Determination 2023/007

Regarding the authority's decision to refuse to grant a building consent for alterations to an existing building

264 McShane Road, Wainui Bay, Tasman District

Figure 1: Floor plan (not to scale)

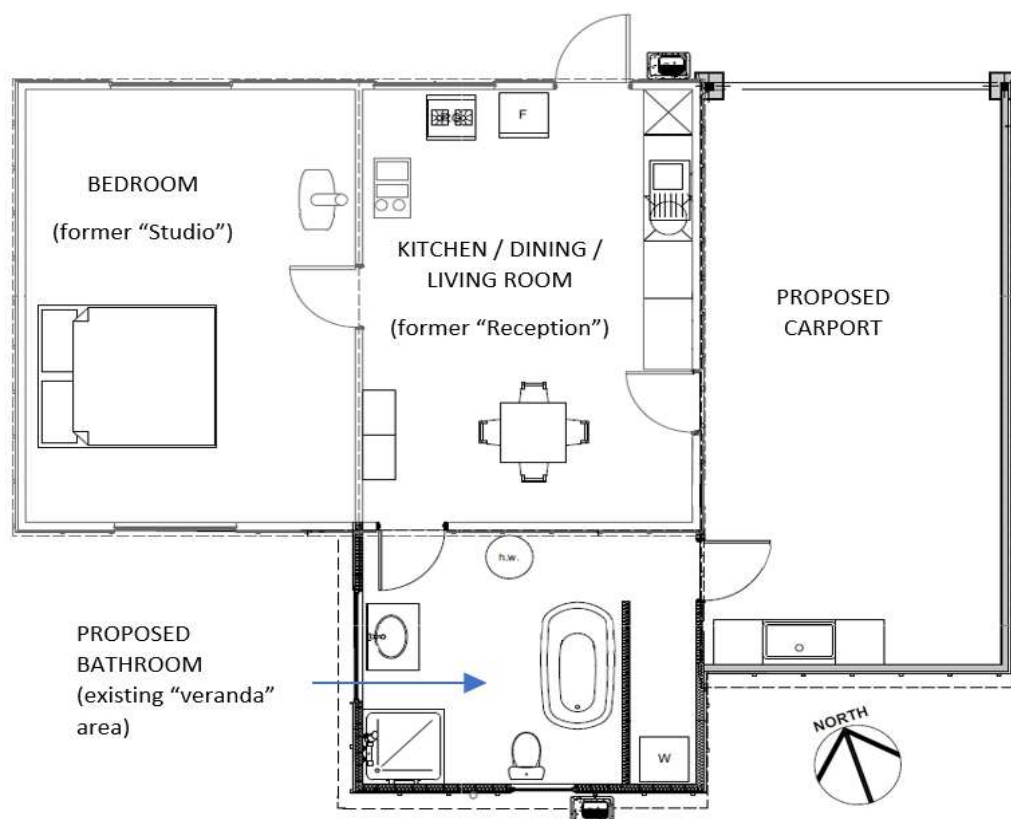
2.5. The building consent plans show that the building will be altered and extended to become a one-bedroom dwelling (refer to Figure 1). Specific aspects of the proposed alterations include (but are not limited to):

- 2.5.2. enclosing the existing veranda to form a new bathroom approximately 15m² in size, with a shower, bath, toilet, hand-basin, laundry space, and hot water cylinder
- 2.5.3. installing a hand-basin in the proposed carport
- 2.5.4. installing new plumbing and drainage
- 2.5.5. carrying out new electrical work and lighting.
